SUBJECT: Response to Request for Additional Information Regarding Relief
Request No. RR-PR-01
Vermont Yankee Nuclear Power Station
Docket No. 50-271
License No. DPR-28

Vermont Yankee Nuclear Power Station
Response to Request for Additional Information

**REQUEST FOR ADDITIONAL INFORMATION FOR
RELIEF REQUEST NO. RR-PR-01
RELATED TO TESTING OF SERVICE WATER PUMPS
ENTERGY NUCLEAR OPERATIONS. INC.
VERMONT YANKEE NUCLEAR POWER STATION
DOCKET NO. 50-271**

OP 4181.01(Q) P-7-1C Vibrations

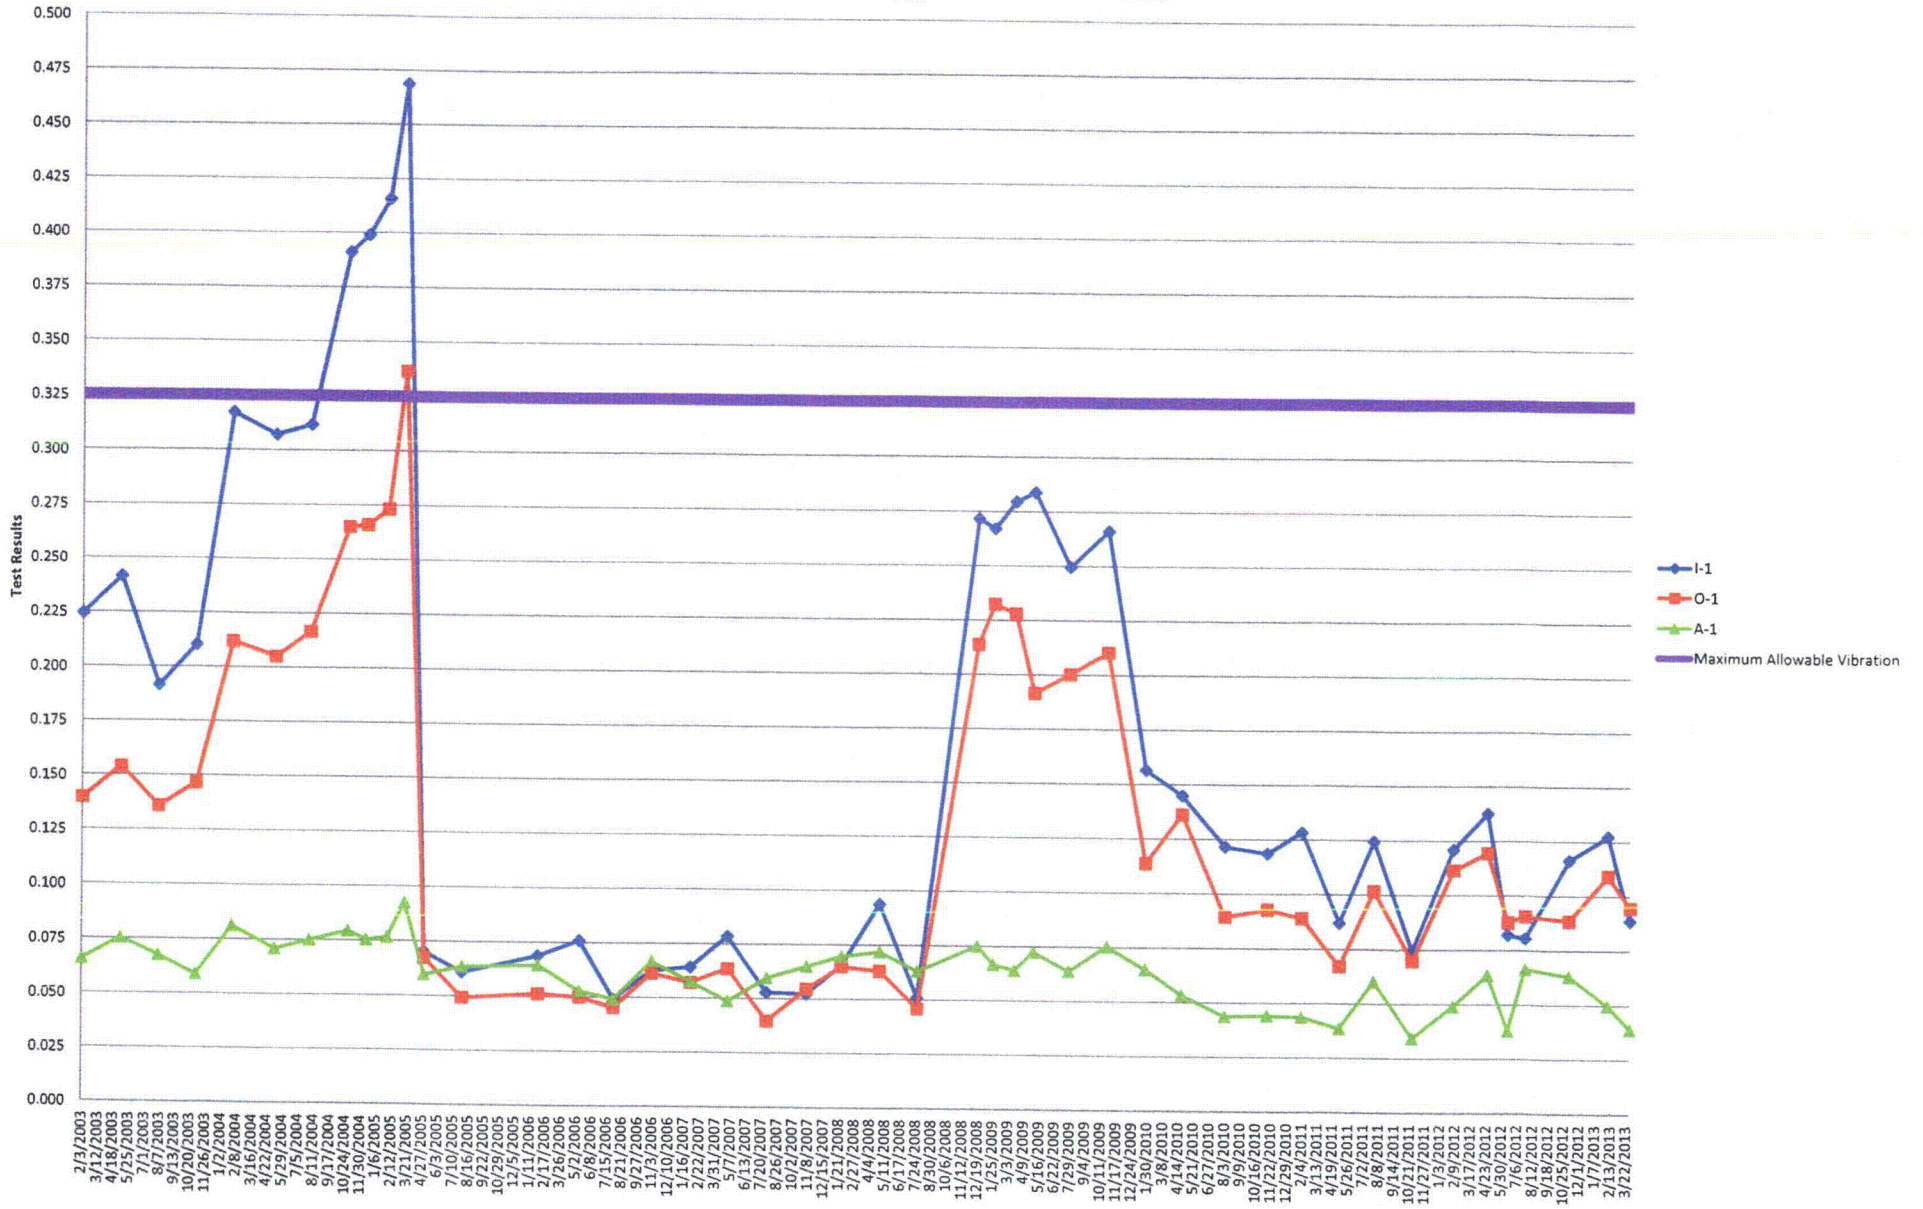
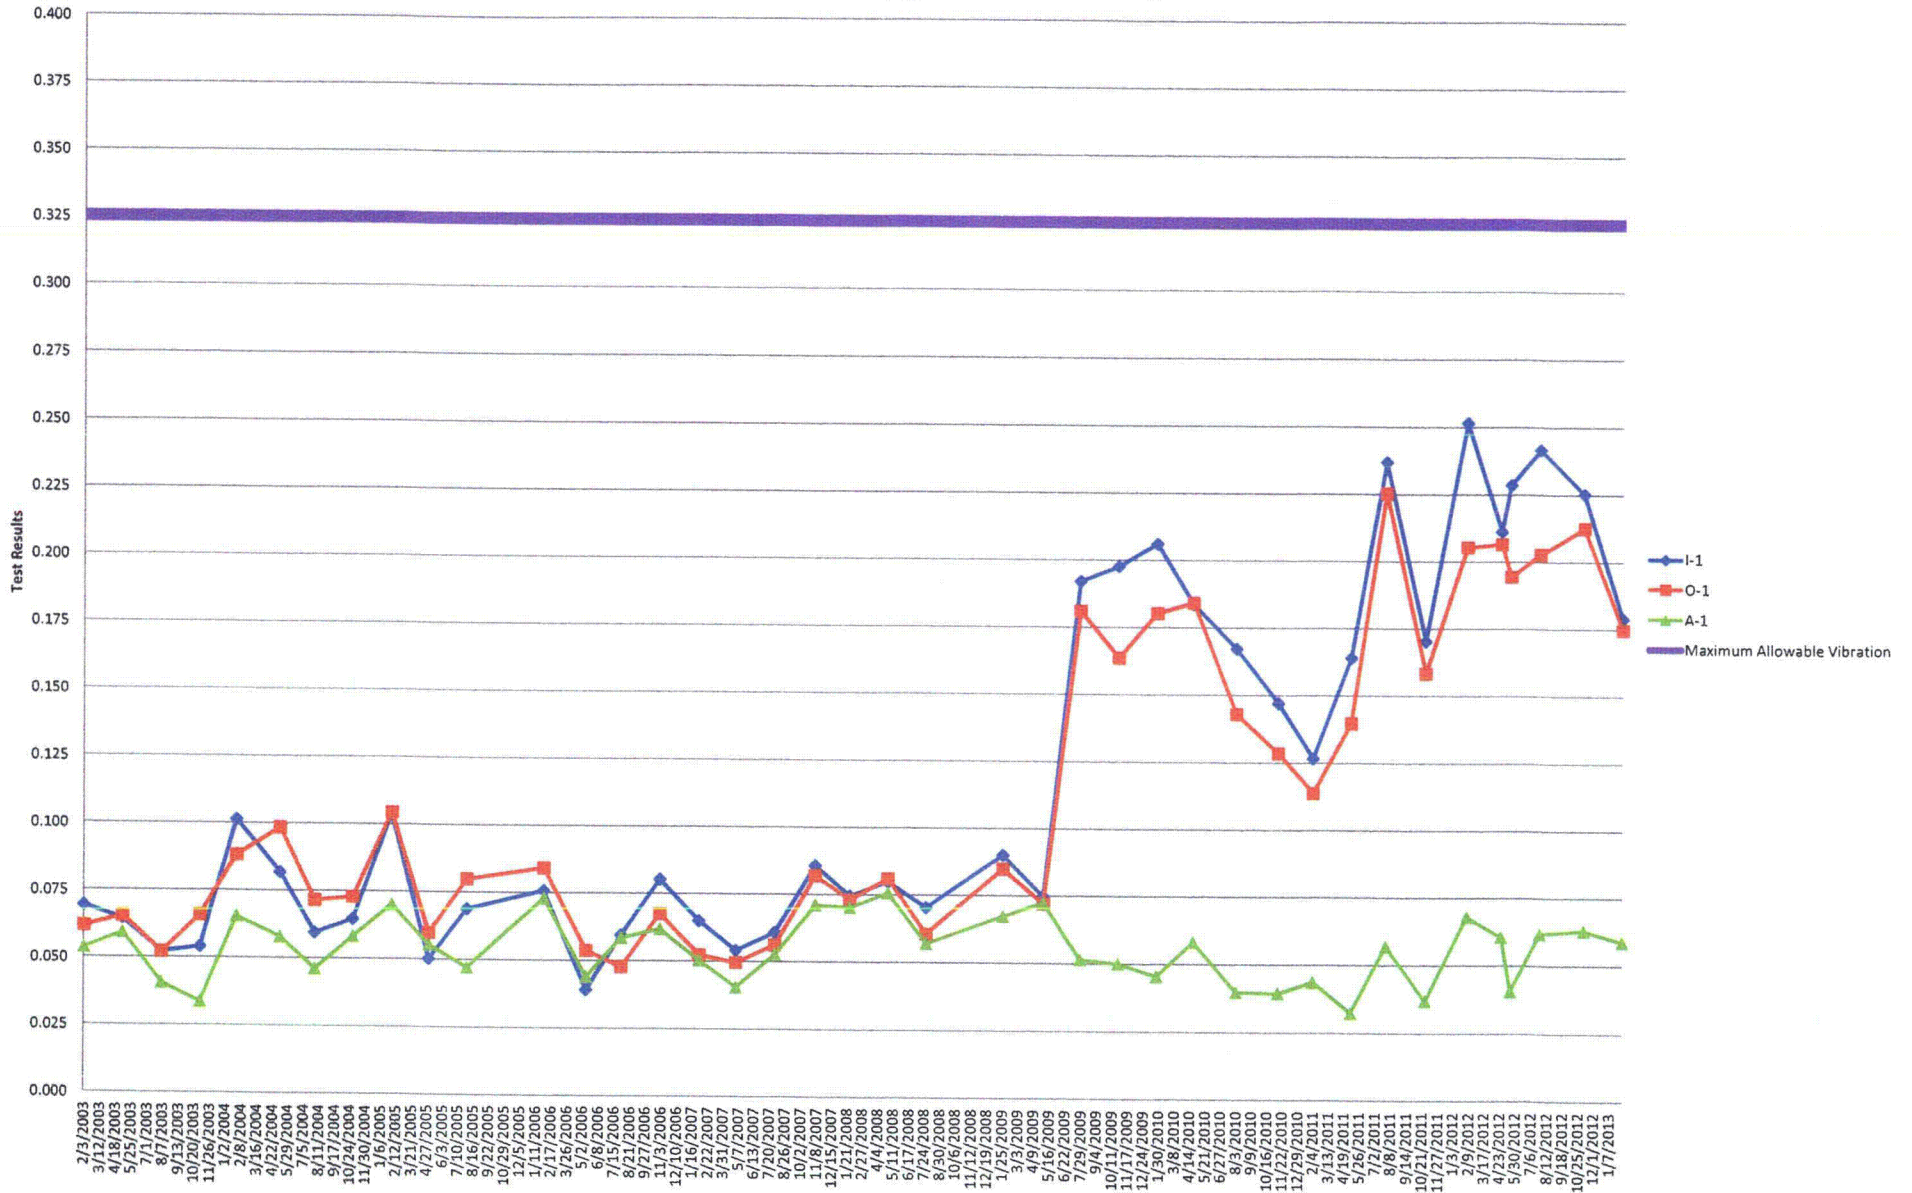
Please provide the inservice test data for the past 10 years for all of the service water pumps noted in this request.

The inservice test (IST) 5-point (capacity) test, quarterly d/p and amperage test, and quarterly pump vibration test data for the past 10 years for all of the Service Water pumps noted in the relief request are included in Attachment 2. Note that vibration data, which is taken at all 5 points during the 5-point test, is not included in capacity test results due to the volume of data.

1. Vibration test data is in units of inches per second. The .325"/sec. is generic OM Code Alert maximum, however point A-1 is approx. ½ of maximum.
2. The quarterly test data is from the IST trend database (original data transferred from completed test forms).
3. The 5-point test data is from the IST "set-up" validation spreadsheet (official data is contained in the completed test form). This data includes the scheduled RFO surveillance and lift adjustments.
